# Staff Report

**Item:** “Brown Street Annexation” (ANX 23-03)

**Tax Lot(s):** 051W18C001200 (1025 Brown St)

## ANX 22-02: Analyses & Findings

**SHEET**  
 Floor Plans

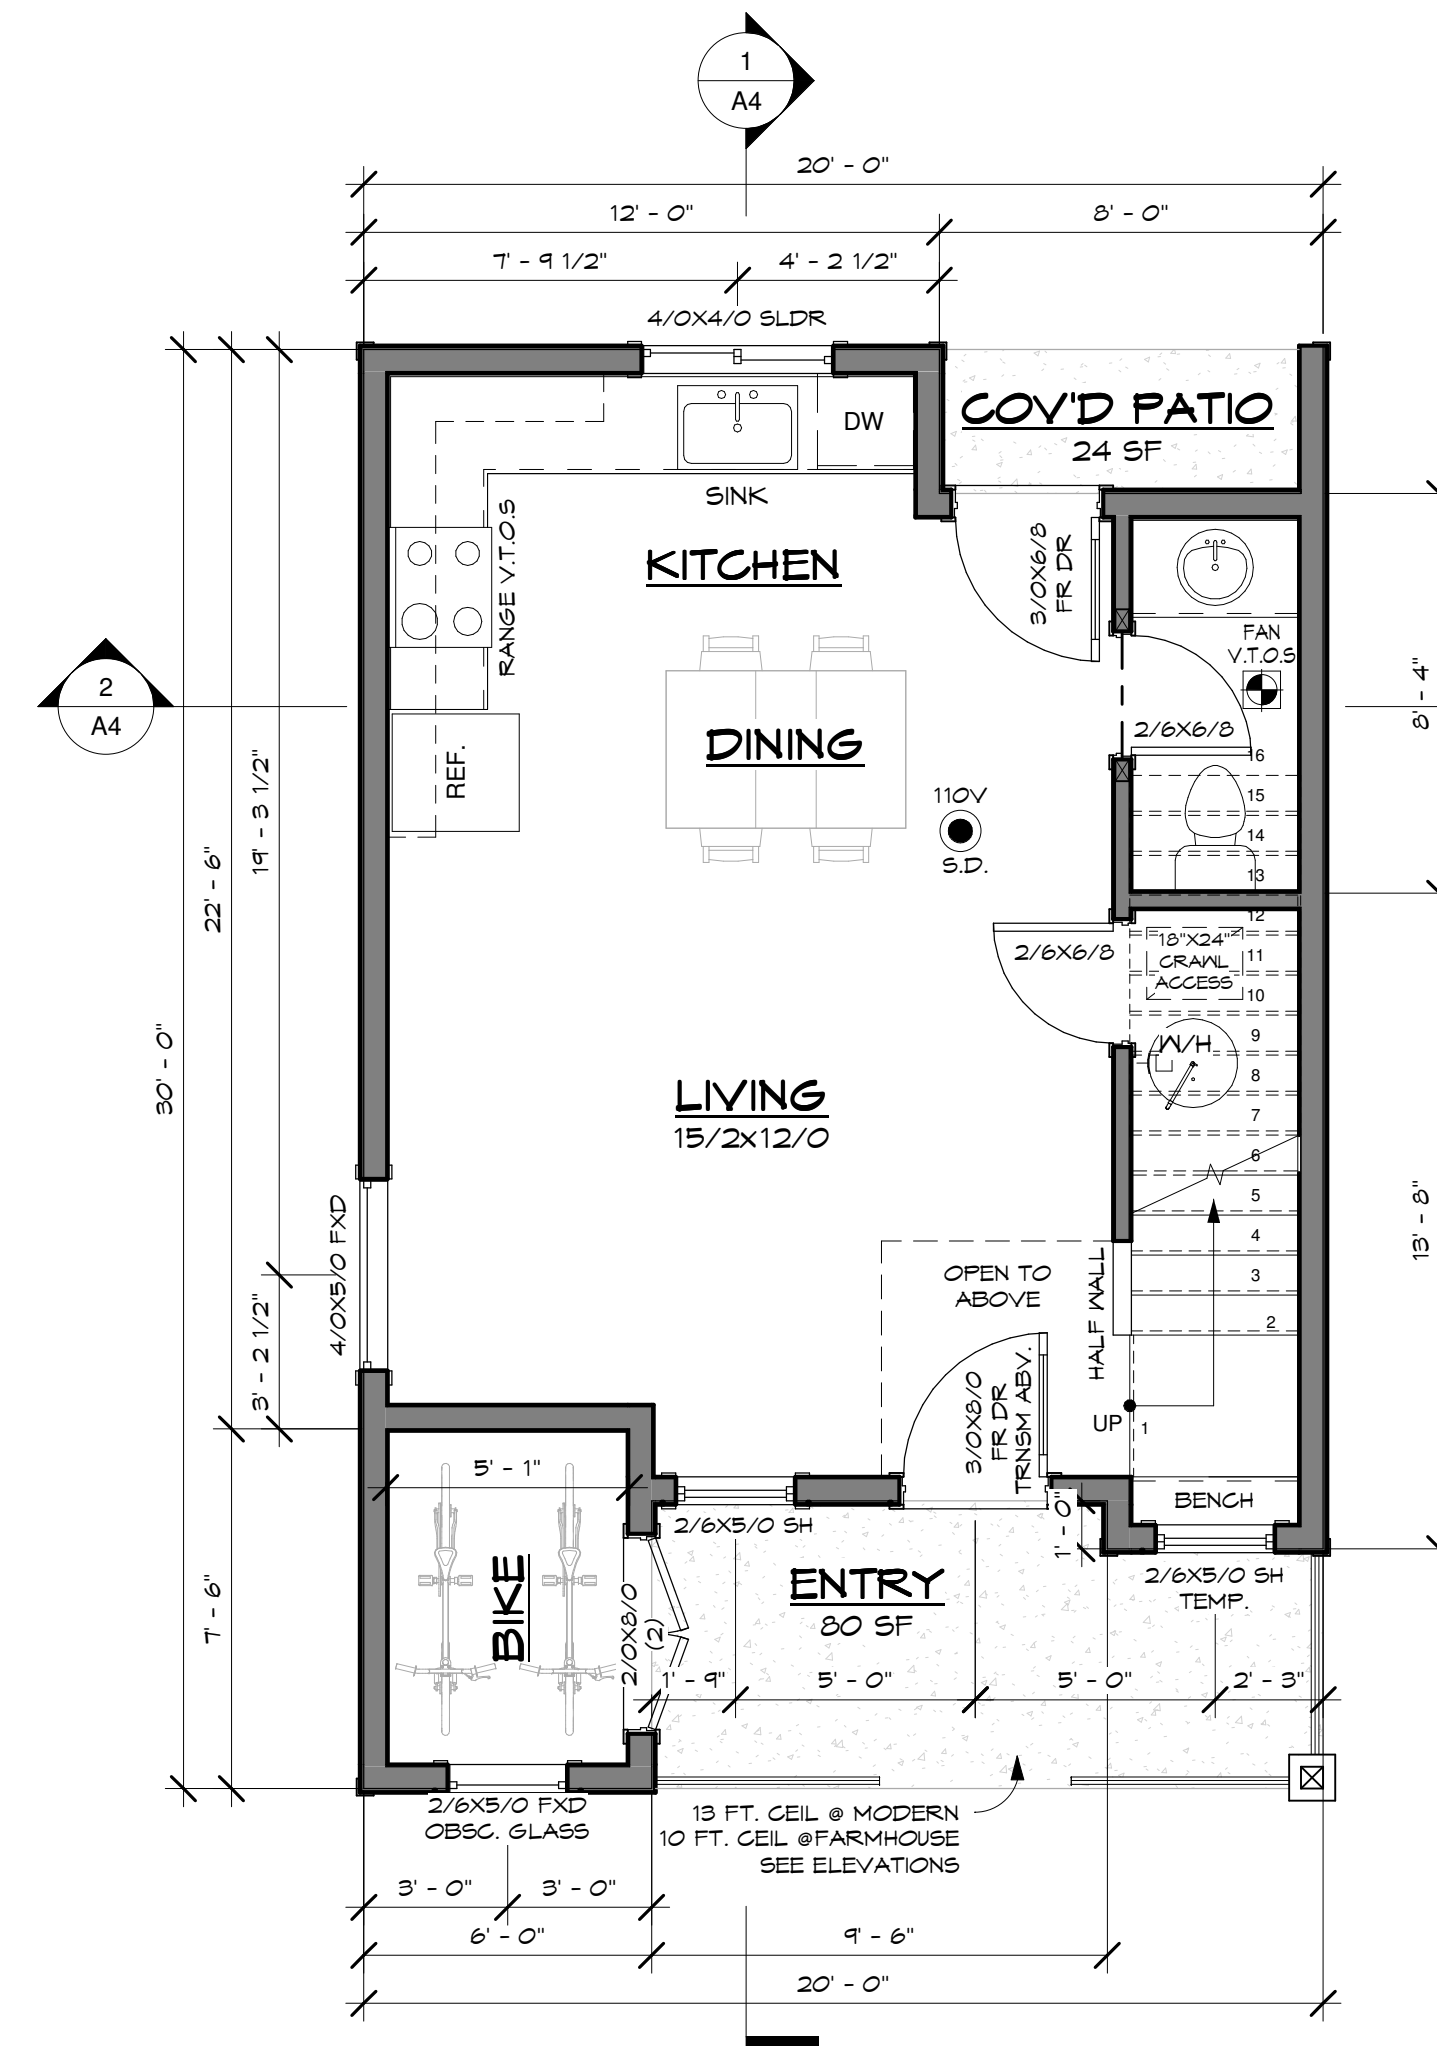
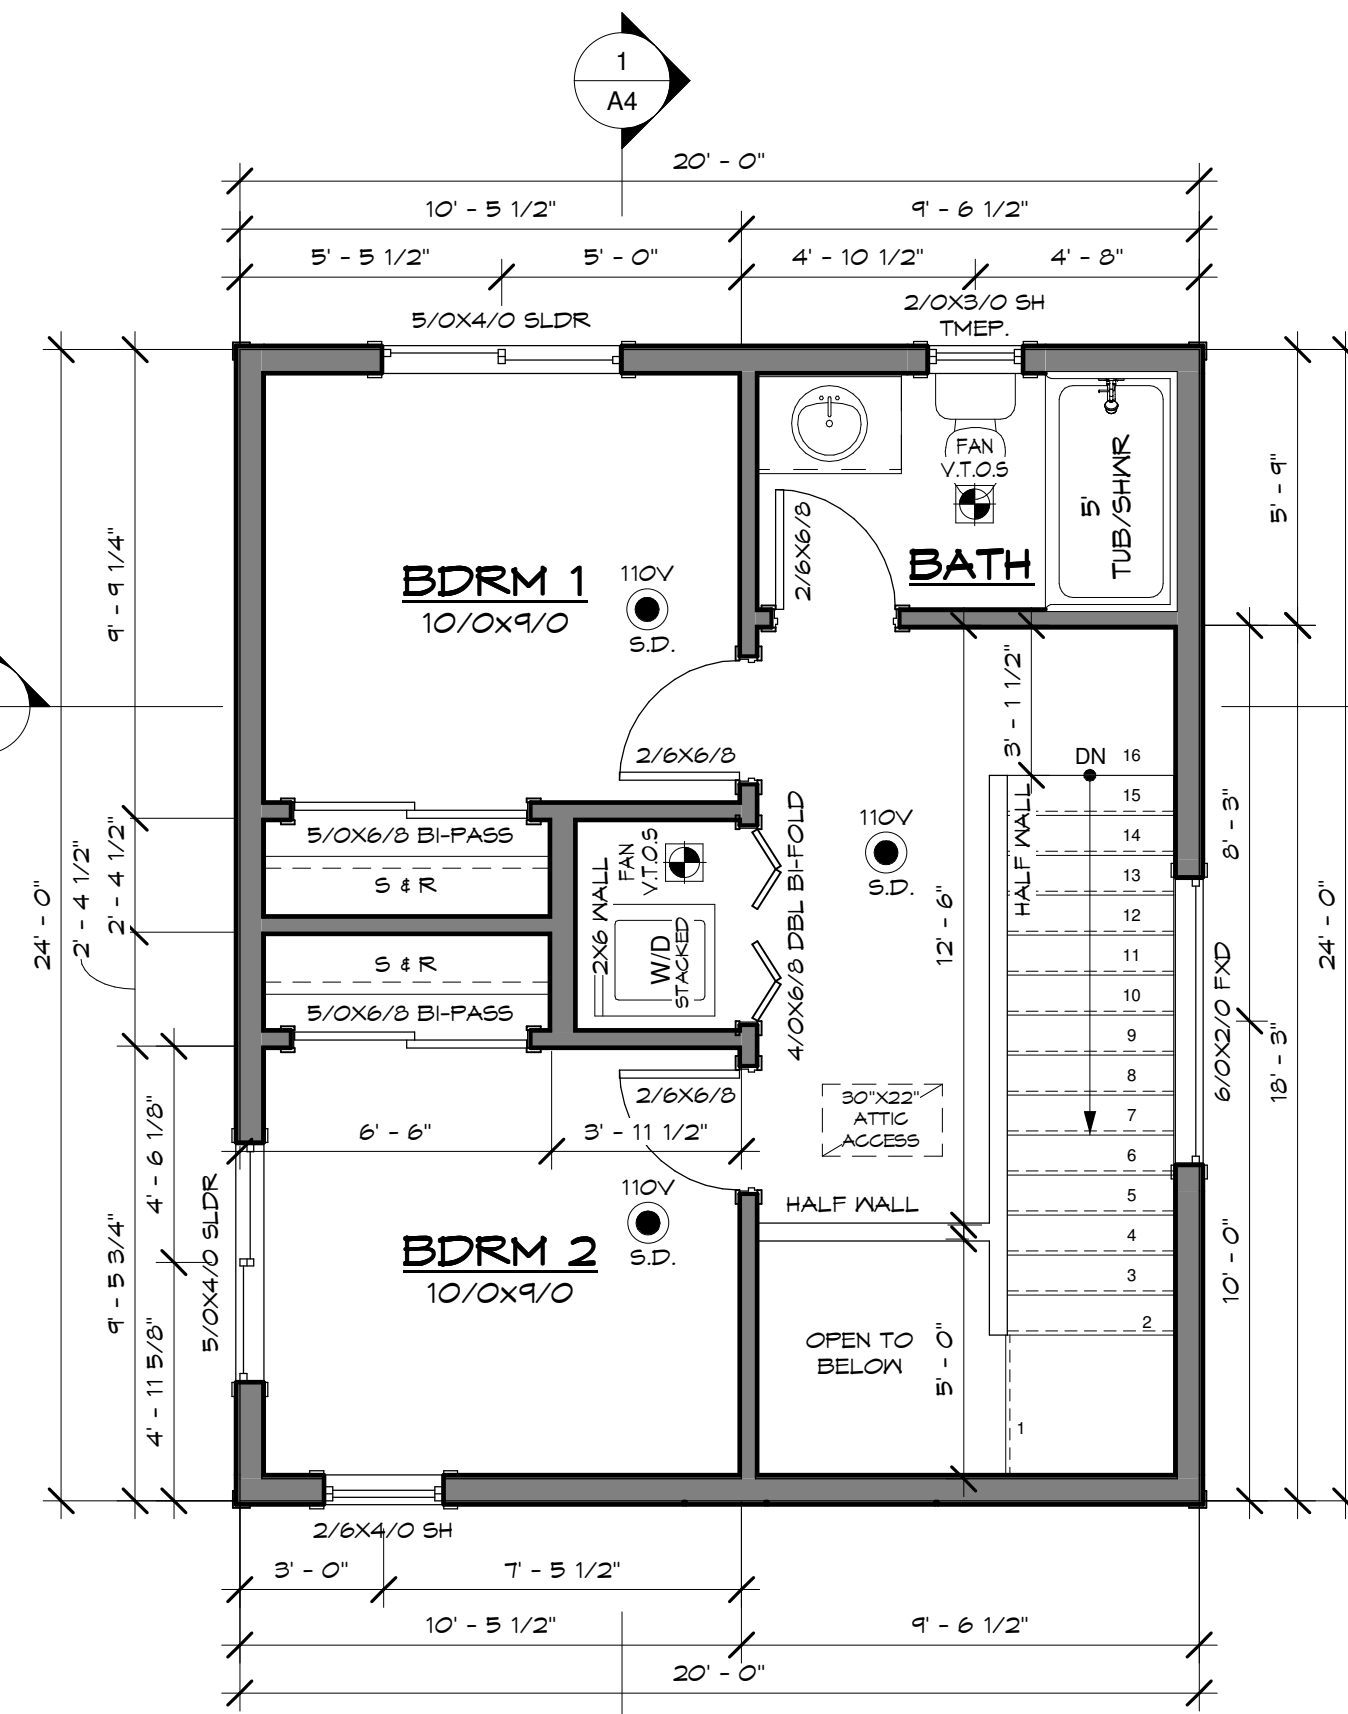
- J. 3.07: Architecture: Table 3.07A: Regarding both the “farmhouse” and “modern” architectural plan sets:
  - 1. E2 “X”: Sheet A3 proposes the front patio at min dimension 5 ft width measured at the bench window projection. The min for the narrowest dimension is 8.5 ft.

- 2. E2 option: The narrative p. 37 table indicates E2 option for points 2, but the points aren’t eligible because Sheet A3 illustrates a front patio proposed off-set (located left of the bench window projection) of 1 ft. The min is 2 ft for a min span of 6.5 ft.

- 5. W1:
    - a. Cottage 17: The blank right façade applied to proposed Cottage 17, the right side of which is street-facing, wouldn’t meet min 15% window area. (Per the Sheet A3 floor plan, candidate locations appear to be at the ground floor half-bath (frosted or translucent window acceptable) and ground and/or second floors at stair landings.)

**A. Annexation: legal exhibits:**

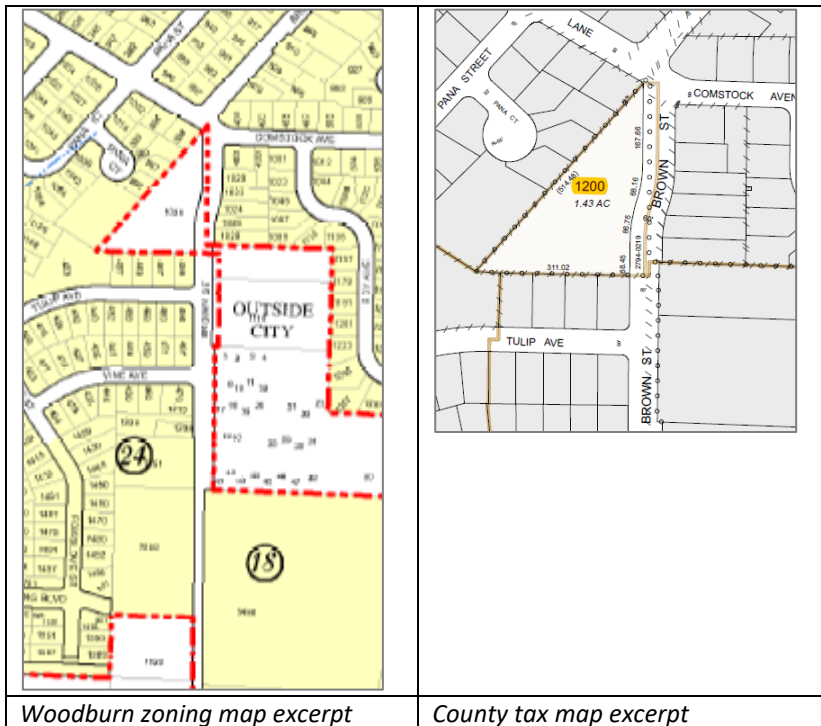
Through the City Engineer April 9, it came to the attention of other staff that some of the adjacent Brown Street right-of-way (ROW) is not also annexed, in part based on the representation on the zoning map and the County assessor tax map:

Per past policy and with a few past annexations as examples, either revise or supplement the legal description and map to include as part of the annexation application that area of ROW not within city limits and lying between the north and south subject property corners.

SHEET  
03  
of  
04

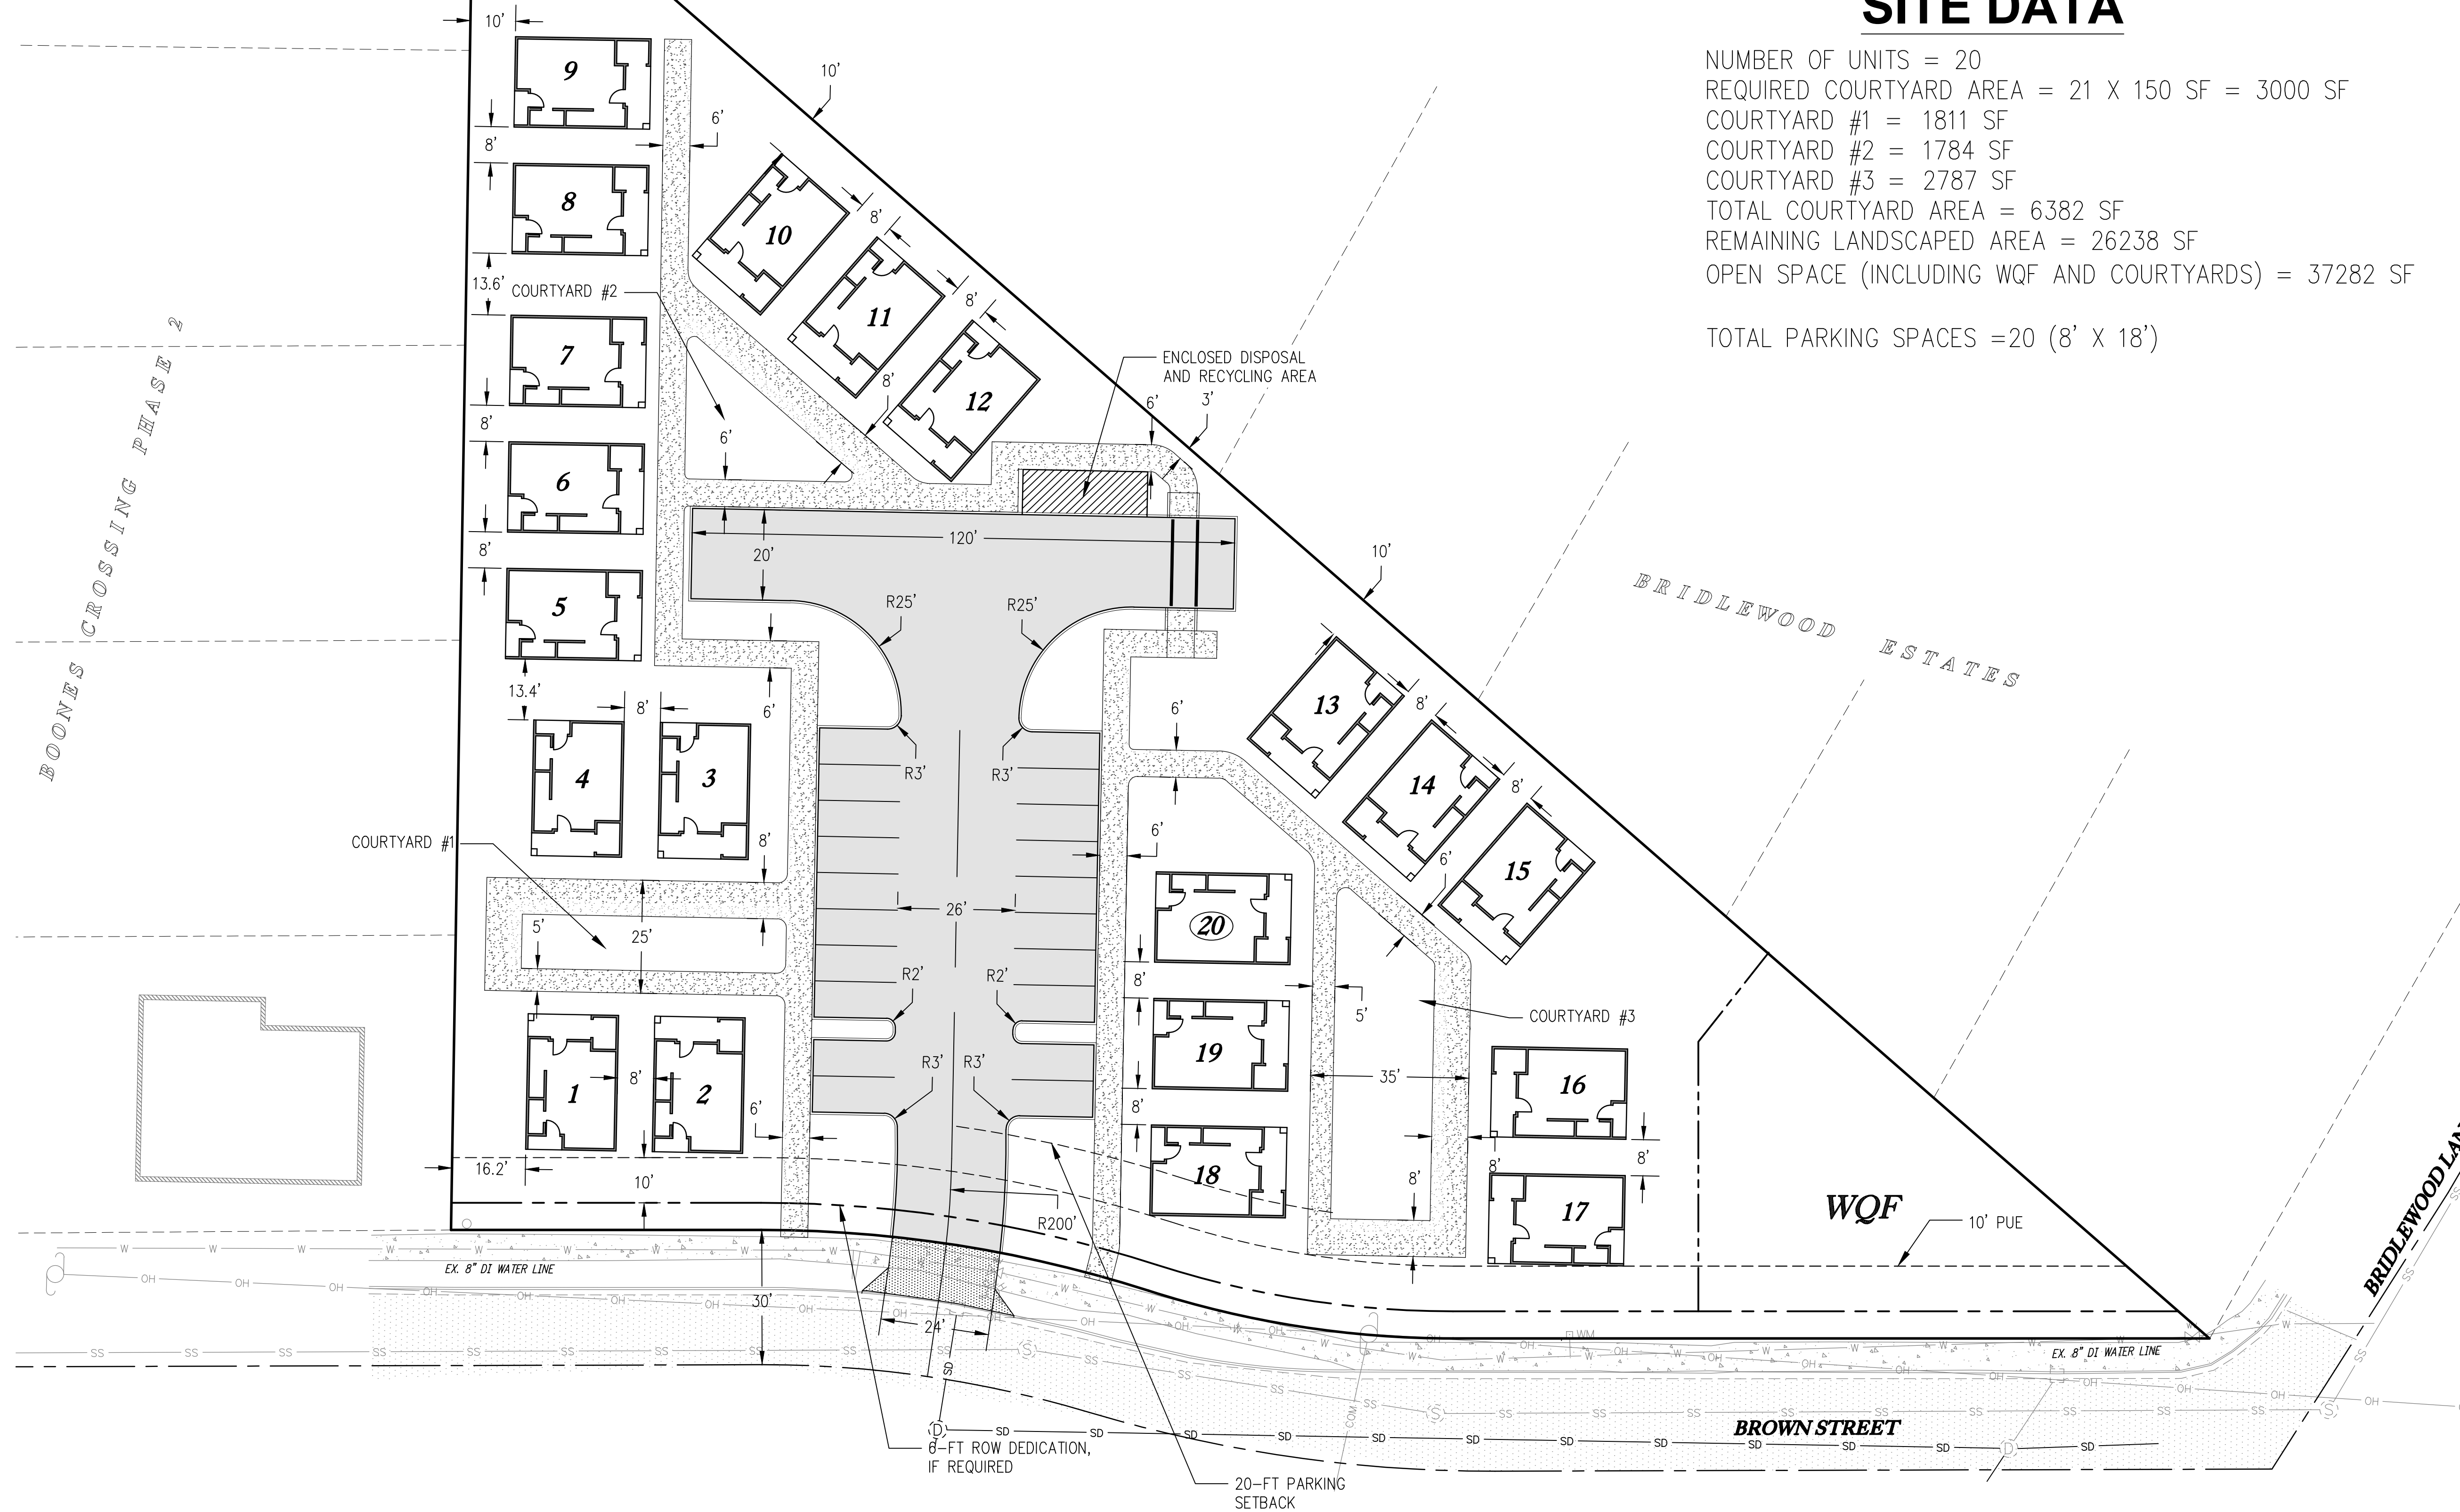
*To conform with 2.07.21C 5 & 6 (cottage footprints and average size), revise the site plan (Sheet 3) to reflect here the information found on narrative pages 6 & 7.*

*To conform with 3.01.02A, 3.01.03C.1e, Figure 3.01A, 3.01.04B, & Figure 3.01D "Service Collector", revise the site plan (Sheet 3) to illustrate and note a west "half-street" upgrade.*

*To conform with 3.02.01F.2a, revise the site and utility plans (Sheets 3 & 4) to narrow to 8 ft the proposed 10-ft wide streetside public utility easement (PUE) that, because of ROW dedication, would displace the existing streetside PUE dedicated through Reel 2794, Page 218, Exhibits A & B (2007).*

**Applicant's Response:** Applicant has revised sheet 3 to describe dwelling footprint areas and unit sizes.

**Applicant's Response:** Applicant has revised sheet 3 to illustrate conceptual half-street right-of-way frontage improvements on the west side of Brown Street that are consistent with the city's standards for Service Collector streets. As discussed in Applicant's narrative, the city may not condition approval of the requested annexation or the cottage cluster development on the dedication of new right-of-way or the demolition and reconstruction of the existing safe, functioning, full-service right-of-way improvements for the following reasons:

**Applicant's Response:** Applicant has revised sheet 3 and sheet 4 to reduce the conceptual right-of-way dedication from 10-feet to 8-feet. Applicant's agreement to display a conceptual right-of-way dedication is not an acknowledgment of any duty or intention to dedicate additional right-of-way or construct any new right-of-way improvements as a condition of the city's approval of the requested annexation or the proposed cottage cluster development.
